Architectural Commission Report

Meeting Date: Wednesday, November 20, 2013

Subject: **OCEAN PRIME**
9595 Wilshire Boulevard

Request for approval of a façade remodel, landscaping, outdoor dining elements, business identification signage, and a sign accommodation to allow business identification signage to project above the top surface of an architectural element. The Commission will also consider adoption of a Categorical Exemption, pursuant to the California Environmental Quality Act. (PL1330366)

CAMDEN ELEVATION

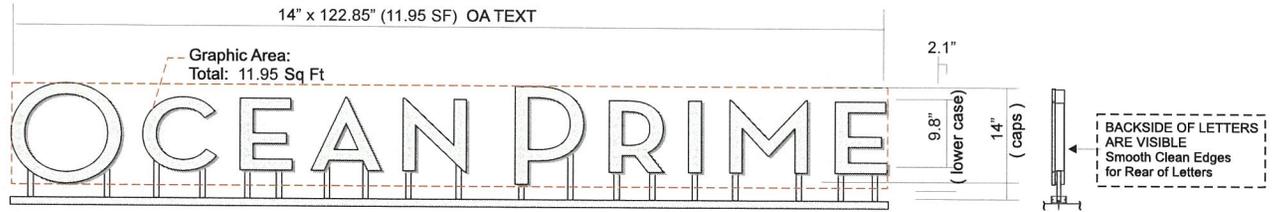
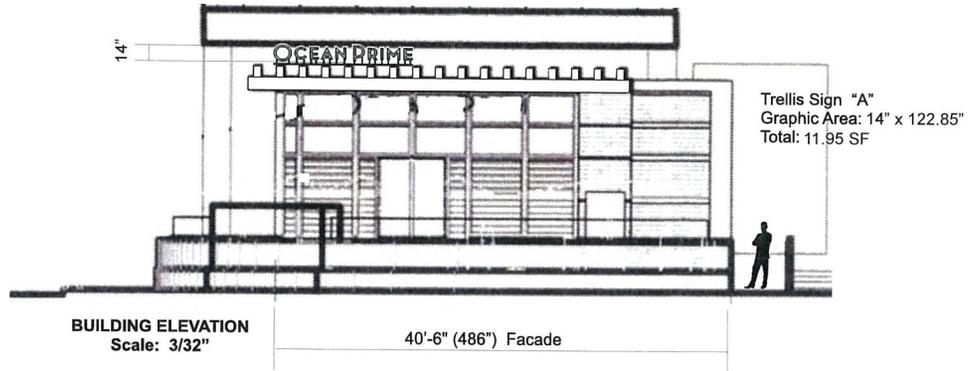
The applicant is also proposing one (1) business identification sign located on the North Camden Drive elevation. The size is proposed at 11.95 SF in area and consists of white acrylic illuminated face channel letters with aluminum returns.

Pursuant to Beverly Hills Municipal Code §10-4-604, the maximum sign area for ground floor tenants is two (2) square feet in area for each one foot (1') of ground floor street frontage that such business occupies within the building, with a maximum sign area of 100 SF. Based on a linear storefront of 118'-0", the maximum sign area for this tenant is 100 SF.

As such, the proposed business identification signage is within the maximum standards set forth in the BHMC.

ILLUMINATED FACE CHANNEL LETTERS - Scale: 1/4"

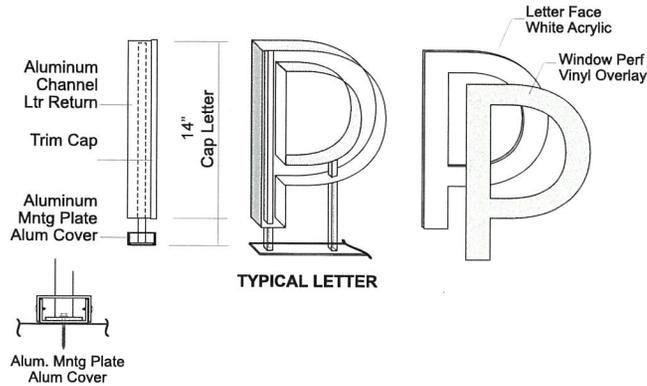
The applicant is proposing one (1) business identification sign, fourteen inches (14") in height, to project above the proposed trellis. The signage consists of white acrylic illuminated face channel letters with aluminum returns.

Pursuant to Beverly Hills Municipal Code (BHMC) §10-4-306, the Architectural Commission may approve a sign accommodation to permit a business identification sign that does not exceed fourteen inches (14") on a marquee, awning, canopy or similar architectural element which projects more than 12" from the face of the building. Awning signage is not included in the total sign area calculations for business identification signs.
